**Subject: Supplemental Application Revisions  
Fairbanks Landfill – Harris County  
Municipal Solid Waste (MSW) – Permit Application No. 1565B  
Major Permit Amendment Application  
Tracking Nos. 17465613 & 17978769; CN602560930/RN100218544**

#### **Attachment 3D.4.2 – Ballast Uplift Calculations**

### **BALLAST UPLIFT CALCULATION**

**Figure 3D.4.2-1: Example Layout at Liner Side Slope**

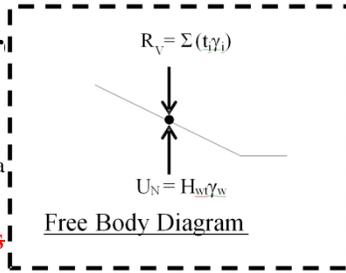
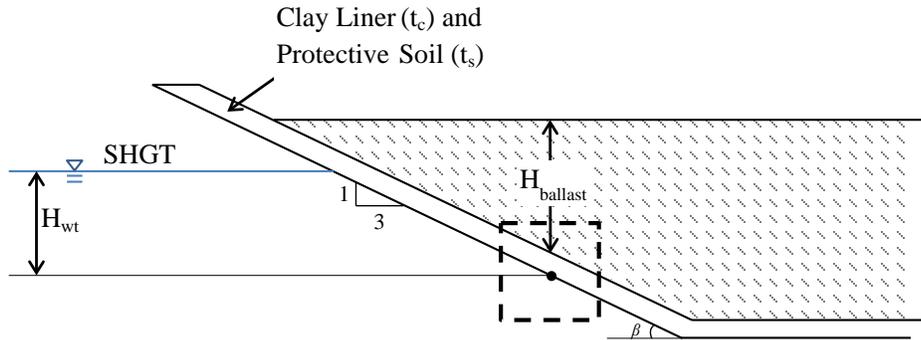
This submittal provides a revised Attachment 3D.4.2, to completely replace the previous version. The previously submitted version of the ballast calculations included a component of uplift resistance due to the lateral earth pressure of the clay liner. For this submittal, the lateral earth pressure component of uplift resistance has been removed from the calculation. The revised uplift calculations are more conservative as a result (i.e., they require slightly more ballast to offset the lack of lateral resistance).

- Select the required long-term factor of safety against uplift (1.2 or 1.5) depending on the ballast material.
- Calculate the maximum hydrostatic uplift force,  $U_N$ , acting normal to the liner (~~see free body diagram in Figure 3D.4.2-1~~) -at each point:

- Calculate the resisting force,  $R_N$ , provided by recompacted clay liner and protective cover soils acting normal to the liner (~~see free body diagram in Figure 3D.4.2-1~~) at each point:

**Figure 3D.4.2-2: Typical/Idealized Cross-Section**

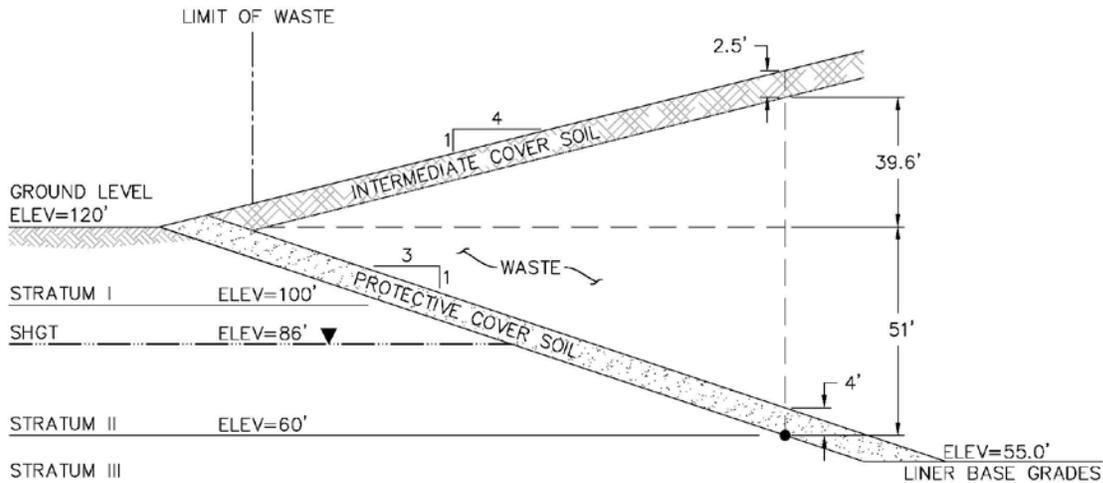
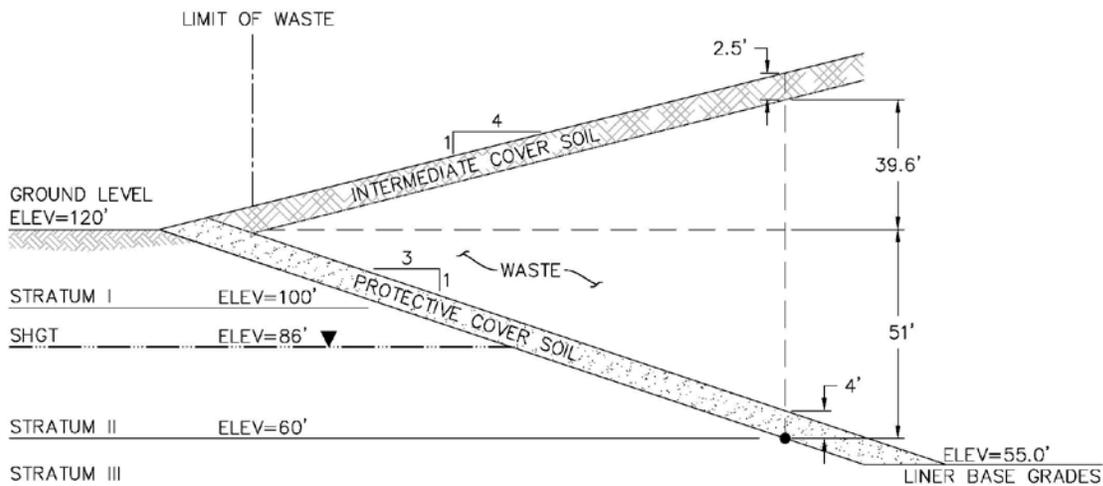
As landfill waste filling progresses, the actual waste thickness will exceed the minimum required thickness of waste-ballast (See Figure 3D.4.2-~~23~~). This demonstrates that waste may be used as ballast, without the need to be supplemented by additional soil ballast placement.

As landfill waste filling progresses, the actual waste thickness will exceed the minimum required thickness of waste-ballast (See Figure 3D.4.2-2). This demonstrates that waste may be used as ballast, without the need to be supplemented by additional soil ballast placement.
